**NO. 1 STOCKPILE TEST PLOT ANNUAL REPORT
REPORT NO. 1**

PHELPS DODGE TYRONE INC.

2.0 RESPONSES TO COMMENTS ON AS-BUILT REPORT

In a November 8, 2006 letter, the MMD and NMED provided comments on the report titled, "*As-Built Report-Cover, Erosion, and Revegetation Test Plot Study-Tyrone Mine Stockpiles.*" The MMD and NMED conditionally approved the report pending satisfactory responses to the conditions listed below. This section details responses to the Agencies' comments.

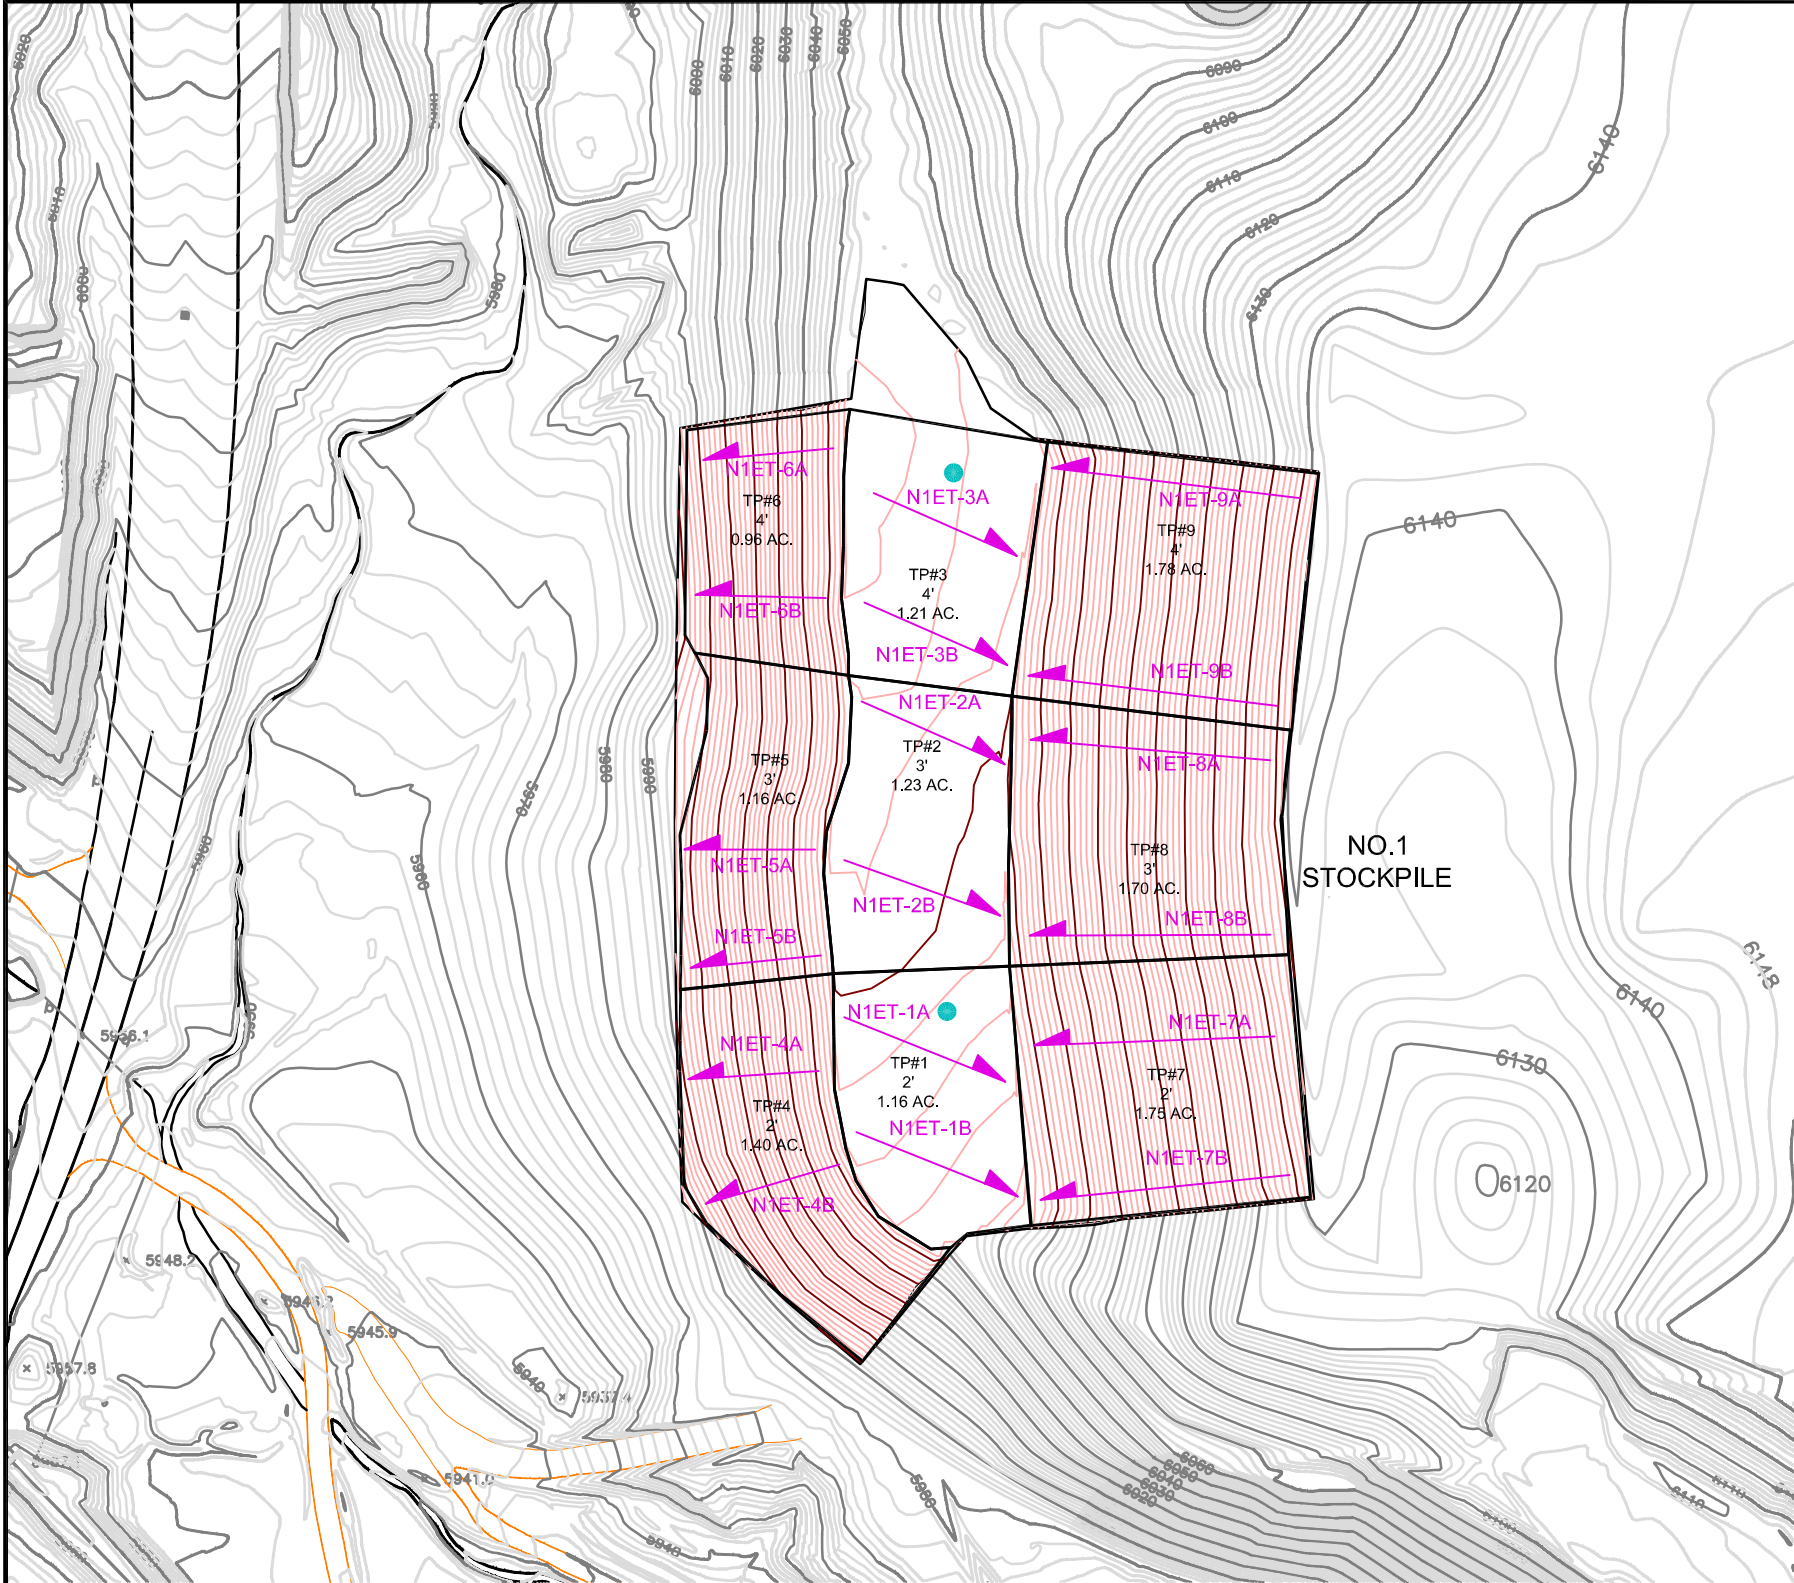
Agency Comment #5

PDTI must include updated maps with the addition of erosion monitoring instrumentation (i.e., pin locations) and the subsidence areas associated with any lysimeters.

Figure 2 is an updated map showing the proposed location of the erosion transects and the approximate lysimeter subsidence zones.

PLATE 1

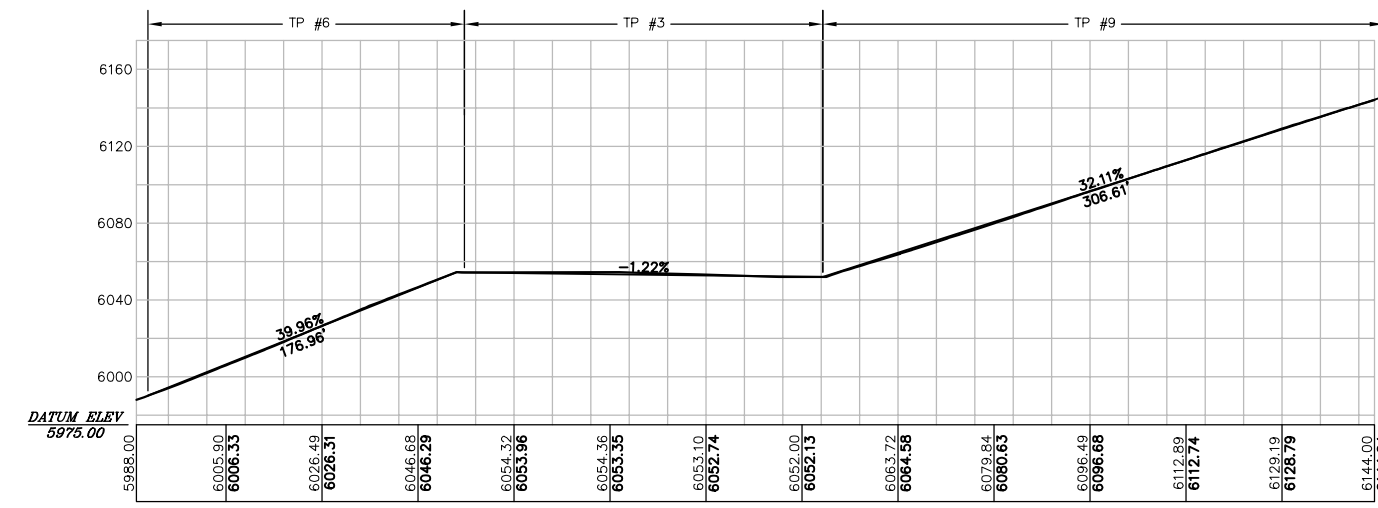
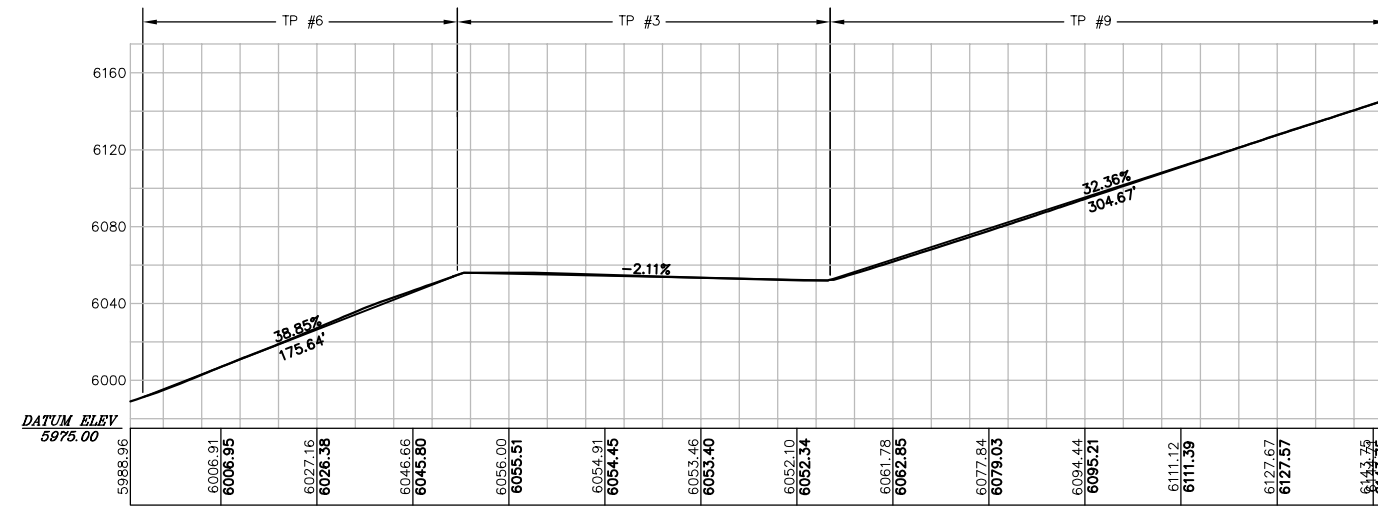
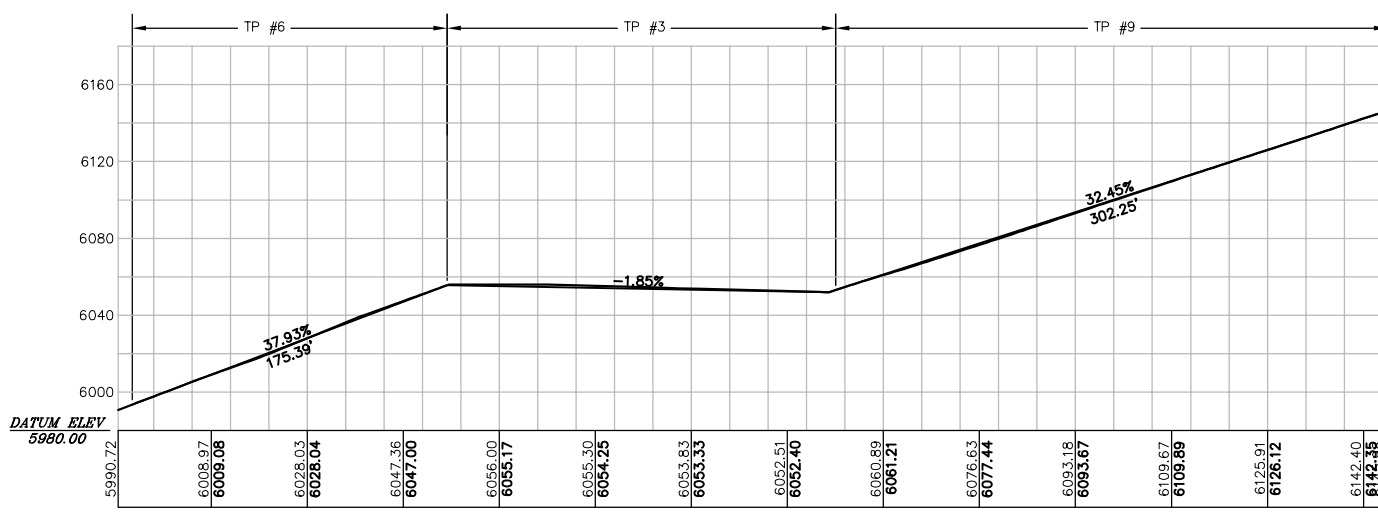
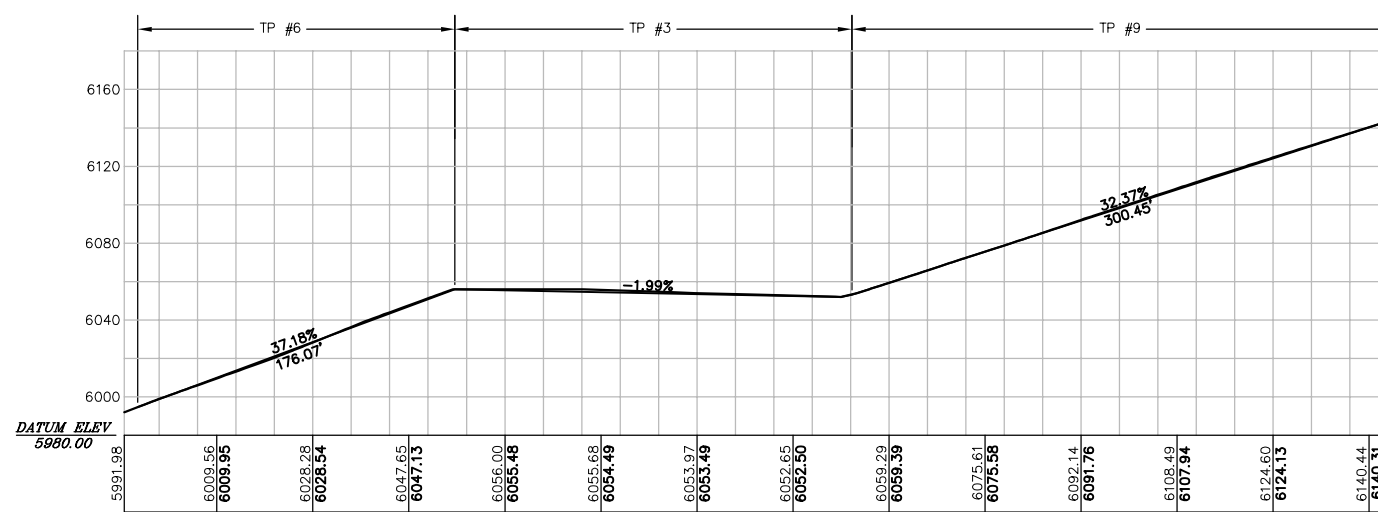
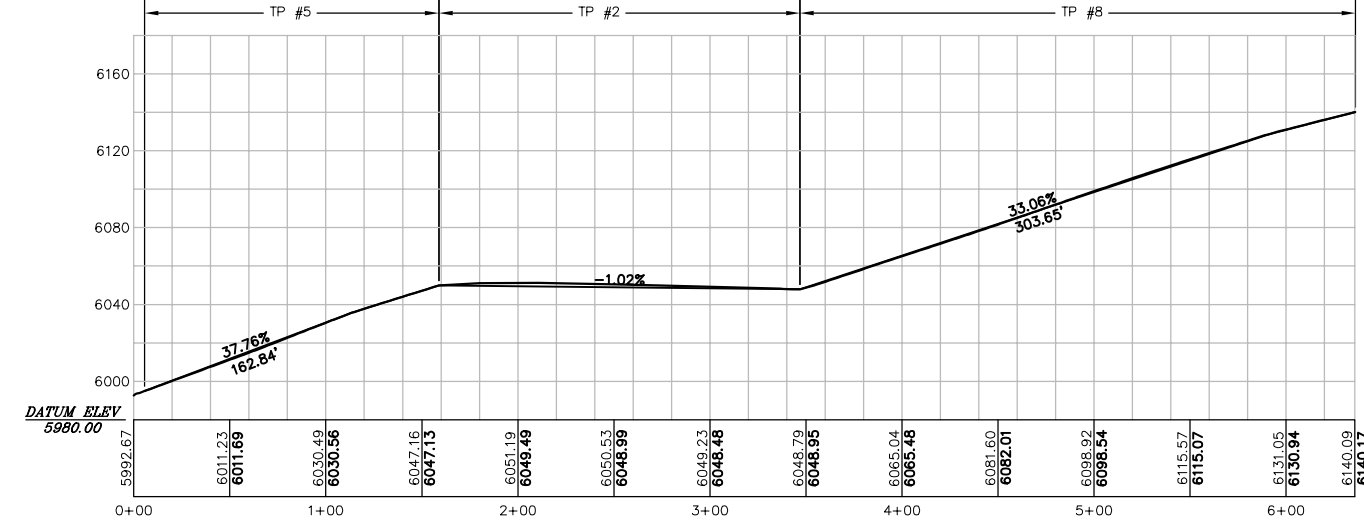
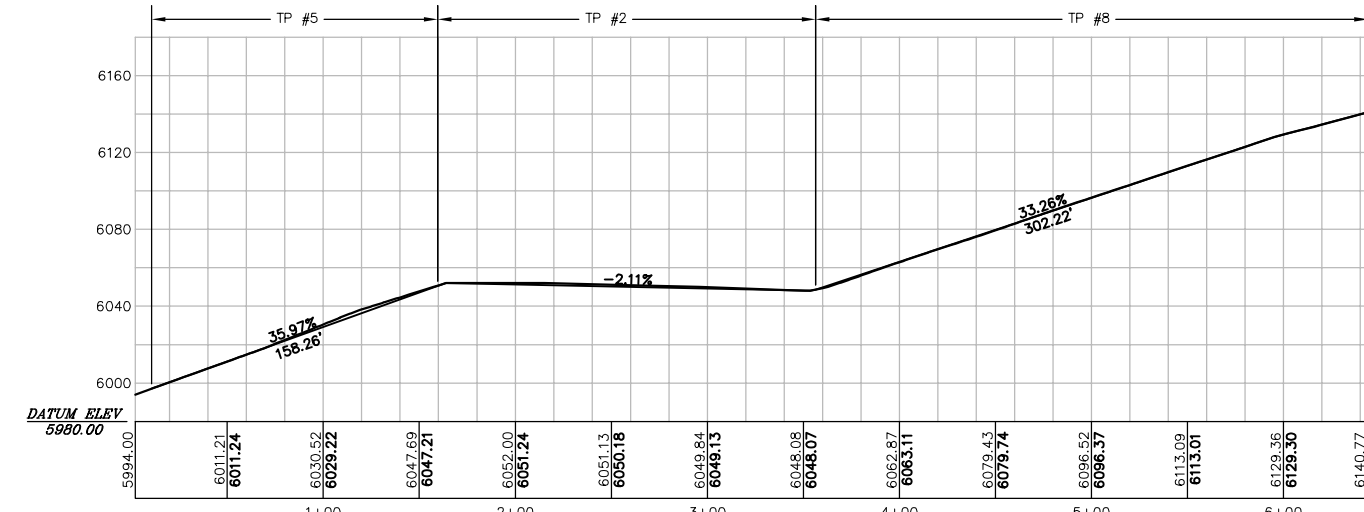
Agency Comment #10

In Section 3.2 and Plate 1, there is some indication that the sloped test plots were flatter and shorter in length than is defined in the permit language. PDTI must explain the causes for the change in grade from the proposed design and if these are due to construction limitations.

Slope profiles on the 3:1 slopes are within a few feet of the specified 300 foot slope length. Slope gradients range from 32.1 to 33.2 percent (3 to 3.1(h):1(v)). Slope lengths in the 2.5:1 test plots are very close to the required 175 feet except for those in TP#5 where the existing native topography at the base of the slope limited slope lengths to about 160 feet. Slope gradients in the 2.5:1 plots range from 2.5 to 2.8:1 and are within the limits of construction. Plate 1 provides additional cross-sections.
